Re: NOIA Responses – Comment #7
Shelby Crushed Stone - Medina Mine Expansion

This letter addresses hydrogeologic-related comment #7 by Mr. Robert Call (NYSDEC) in the February 14, 2020 Notice of Incomplete Application (NOIA) for the referenced site (Mine ID #80346). The comment is provided below, along with our response.

FIGURE 1
Site Location Map

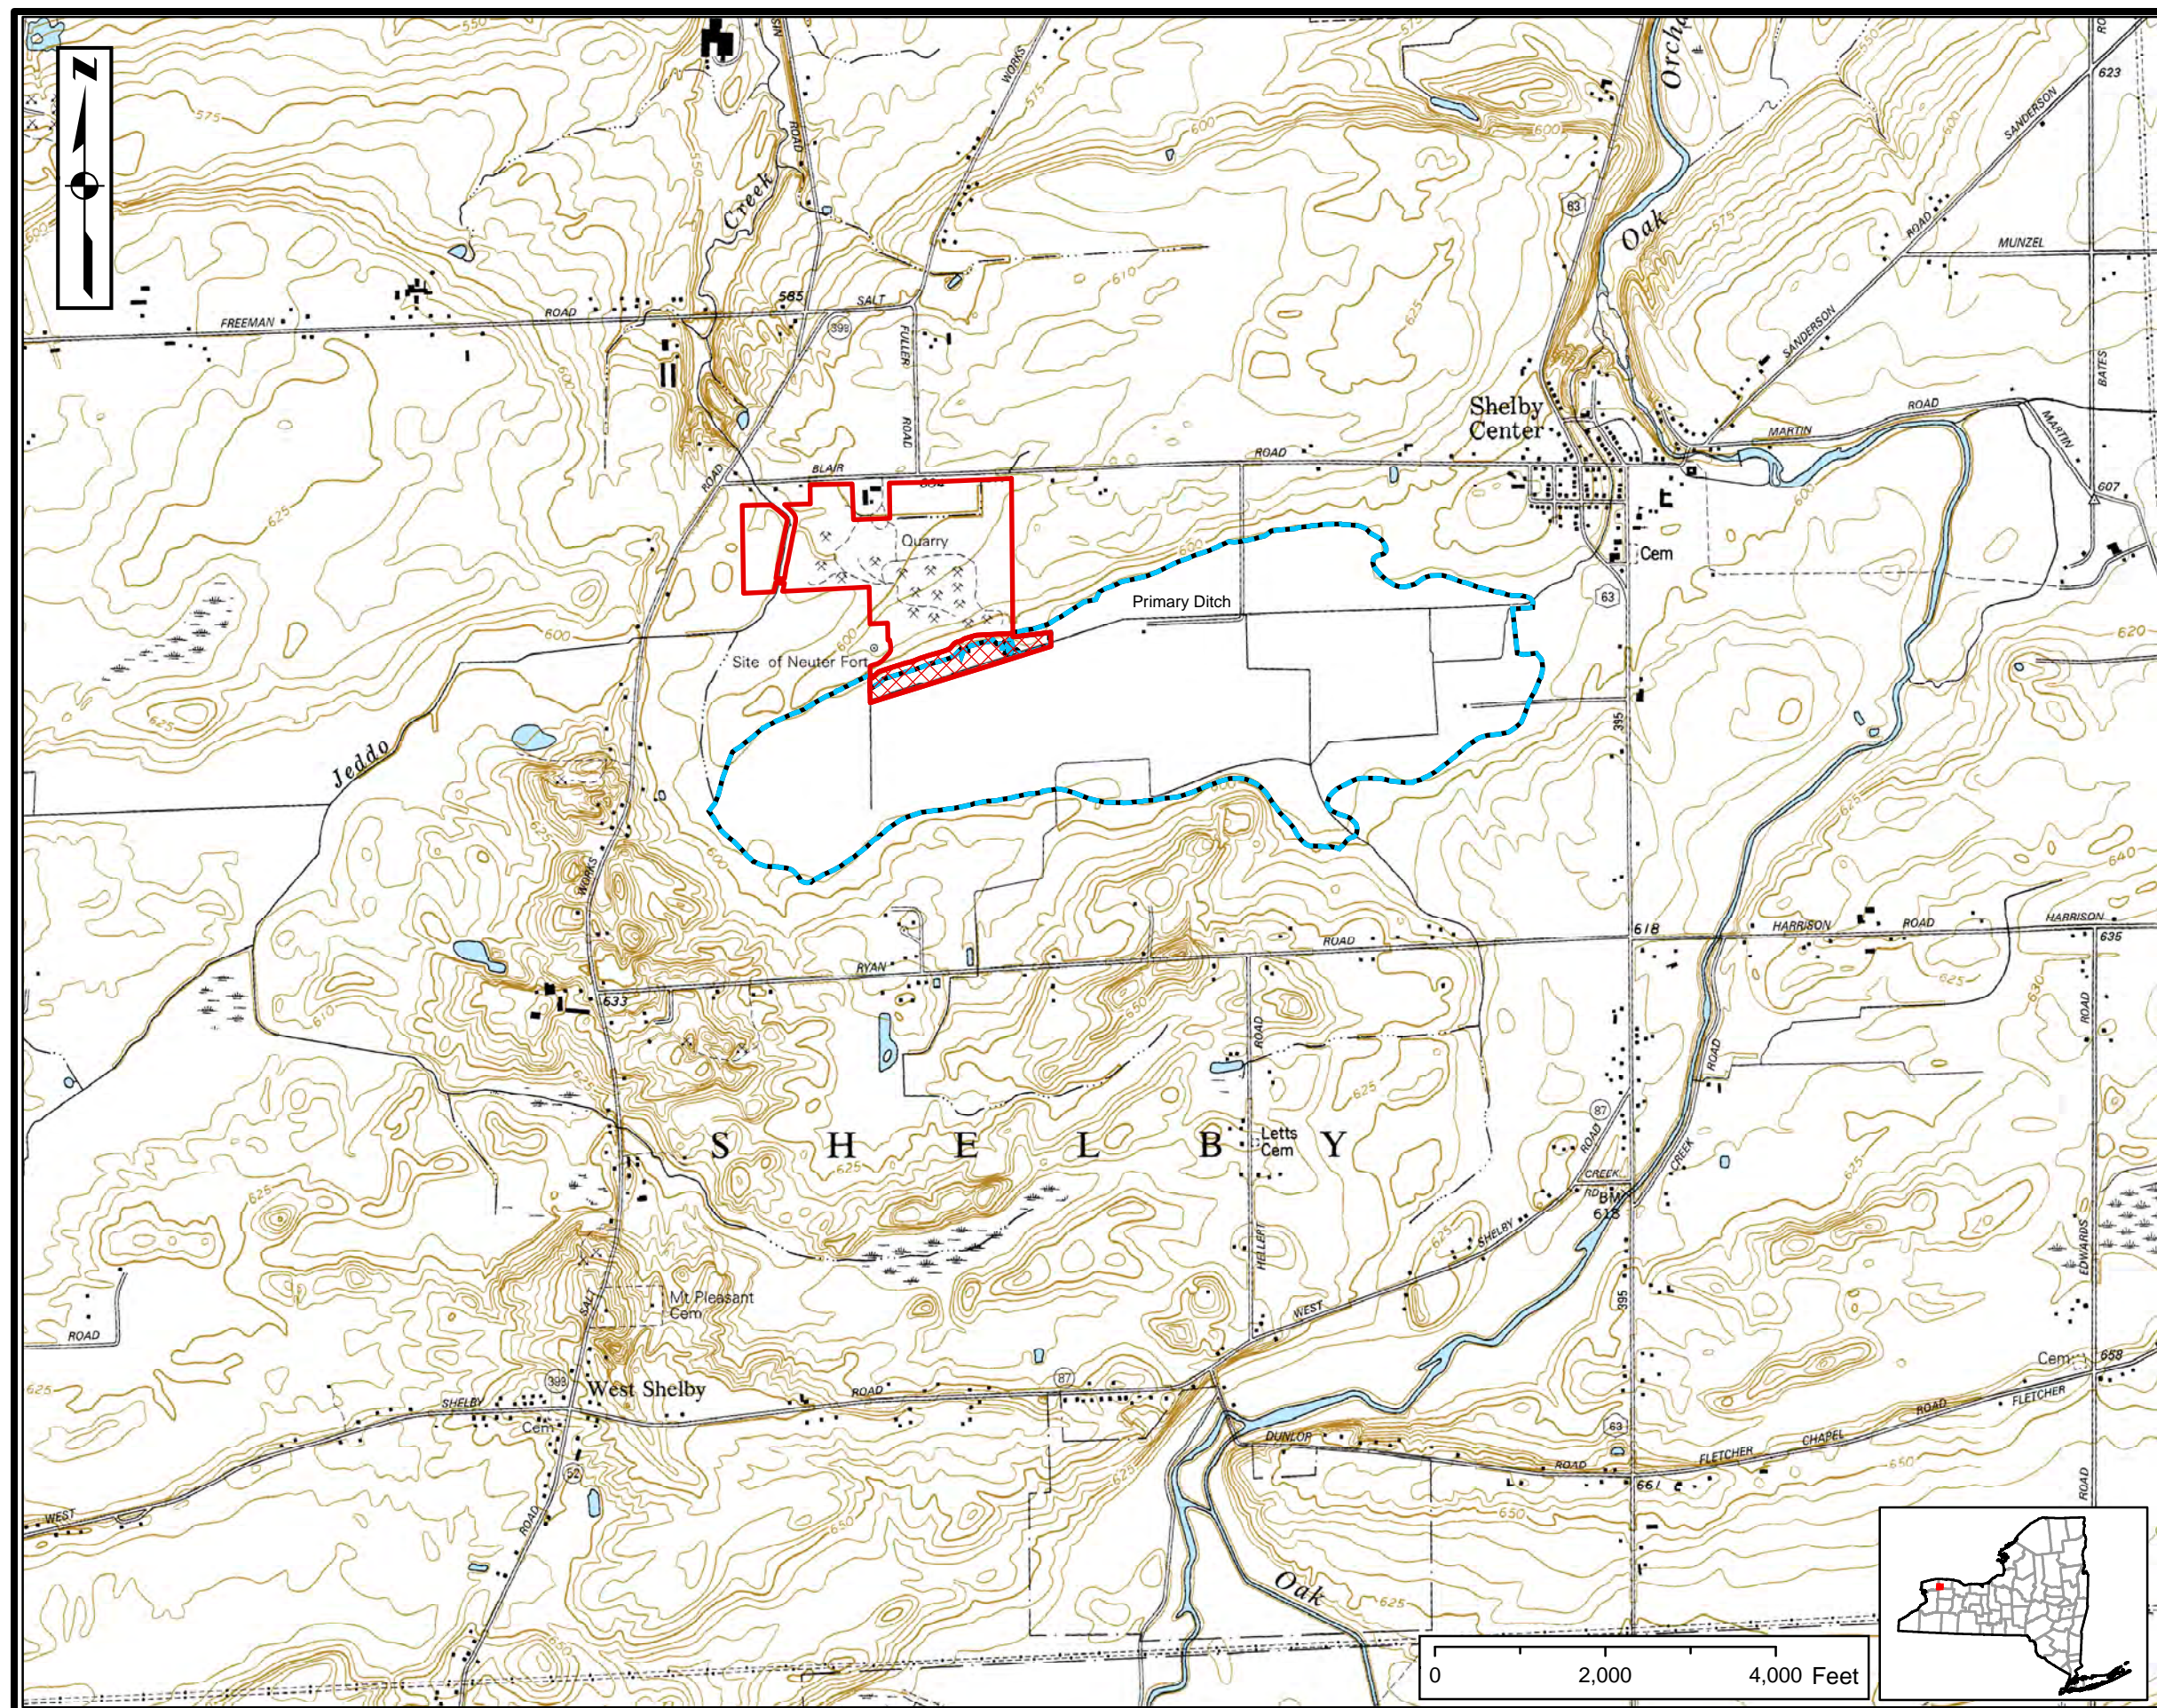
NYSDEC Comment #7: The Department is currently considering the information provided regarding how the project meets the Freshwater Wetlands standards and is also assessing the significance of potential impacts to the resource. As the proposed expansion area is centrally located in the middle of the 502-acre wetland, concerns include the potential ecological impact of bisecting the larger wetland resource. While it is hypothesized that there will be "no significant hydrogeologic impacts to the remaining wetland", the larger question is if the activity will result in no more than an insubstantial degradation to any part of the wetland. Please discuss in greater detail the potential ecological impacts to MD-9, and detail any measures proposed to assure that the larger wetland will not continue to be bisected.

The approximate extent of MD-9, the current life-of-mine (LOM) and the proposed expansion area are shown on Figure 1. The expansion area contains 8.7 acres of delineated wetland that is part of Wetland MD-9 (MD-9). The expansion area is located on the northern edge of the wetland and is not “centrally located in the middle of the 502-acre wetland” as stated in the NYSDEC Comment #7. Also, the expansion area will not be “bisecting the larger wetland resource,” as stated in Comment #7. This is not just a semantic issue. The suggestion that the expansion area is in the middle of the wetland, and that it splits (bisects) the wetland into two parts, misrepresents the facts and is an important clarification that needs to be emphasized, especially given public concern for wetlands in general.

Alpha has been able to show through the ongoing investigations that the hydrology of MD-9 is sustained by direct precipitation to the wetland surface and runoff from the surface water drainage basin that drains into the wetland, which also includes water in the primary ditch (Figure 1) that backs up seasonally due to beaver dams further downstream. Our January 20, 2020 letter to you included an analysis of the hydrology that showed that the wetland recharges the underlying bedrock aquifer, which is the year-round water table aquifer. In other words, the bedrock aquifer does not discharge to or sustain the wetland hydrology. The wetland discharge to the underlying bedrock aquifer is very slow due to the fine grained, low permeability nature of the wetland substrate. It is because of these conditions that the primary impact on the wetland hydrology can be assessed by considering how the removal of 8.7 acres of MD-9, at the edge of the wetland, will affect the quantity of direct precipitation to the wetland, the surface water runoff to the wetland, and the rate of surface water drainage from the wetland. Since there is no change to the surface water drainage system from the wetland by the removal of 8.7 acres from the northern edge, then the direct precipitation and runoff quantities are the most important physical parameters of interest. These are best evaluated by a water budget analysis.
